## **CAMDEN POINTE SUBDIVISION**

APPLICATION NUMBER 16 DATE February 3, 2011  
APPLICANT Camden Pointe Subdivision  
REQUEST Subdivision

# DETAIL SITE PLAN

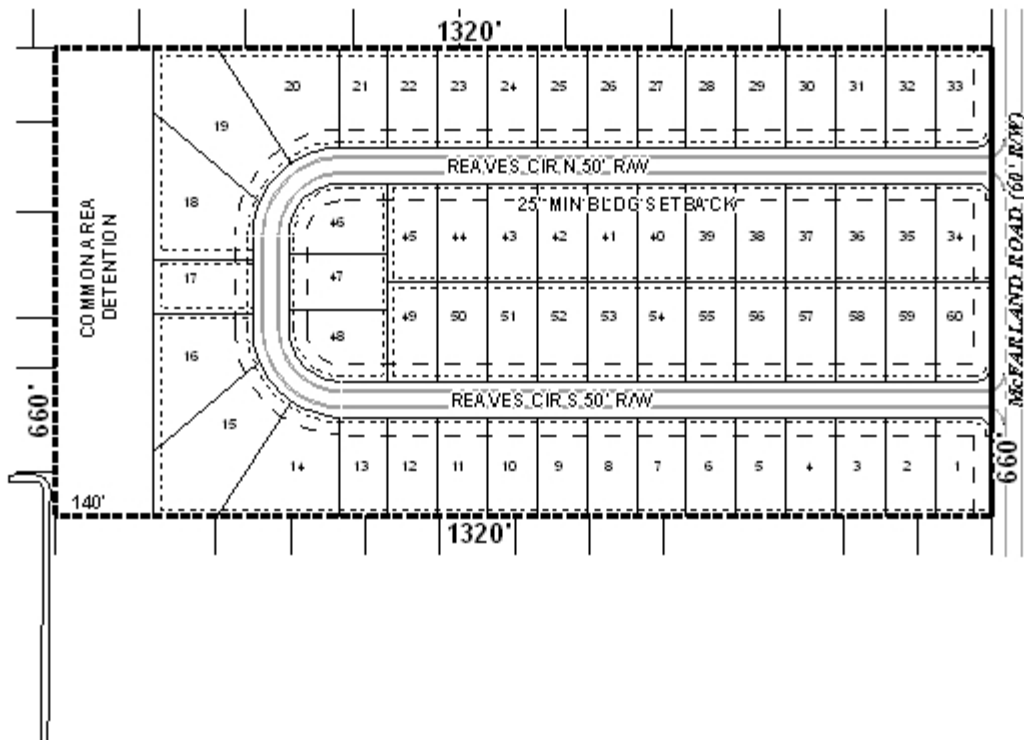
Lot sizes for are not labeled on the preliminary plat. Labeling of the lot area size, in square feet, or provision of a table on the Final Plat with the same information will be required if approved.

Development of the site will require the construction of new streets, which will connect to existing minor streets to the East of the site. All roads must be built to County standards and accepted by the County, prior to the recording of the Final Plat.

Common areas are proposed for the site. Notes regarding the common areas, including the detention area, stating that maintenance shall be the responsibility of the property owners, should appear on the Final Plat.

The 25-foot minimum building setback is shown on the plat, and should be placed on the Final Plat, if approved.

- 1) construction of all streets to Mobile County standards, including the street-stub to the East, and acceptance of the streets by Mobile County prior to the recording of the final plat;

- 2) placement of a note on the Final Plat stating that each lot is limited to one curb-cut, with the size, design and location to be approved by Mobile County Engineering;

- 3) labeling of the 25-foot minimum building setback line, and placement of the note on the plat;
- 4) placement of a note on the Final Plat stating that the development will be designed to comply with the storm water detention and drainage facility requirements of the City of Mobile storm water and flood control ordinances, and requiring submission of certification from a licensed engineer certifying that the design complies with the storm water detention and drainage facility requirements of the City of Mobile storm water and flood control ordinances prior to the issuance of any permits. Certification is to be submitted to the Planning Section of Urban Development and County Engineering;

- 7) labeling of the lot area size, in square feet, or provision of a table on the Final Plat with the same information, with changes as necessary due to dedications.
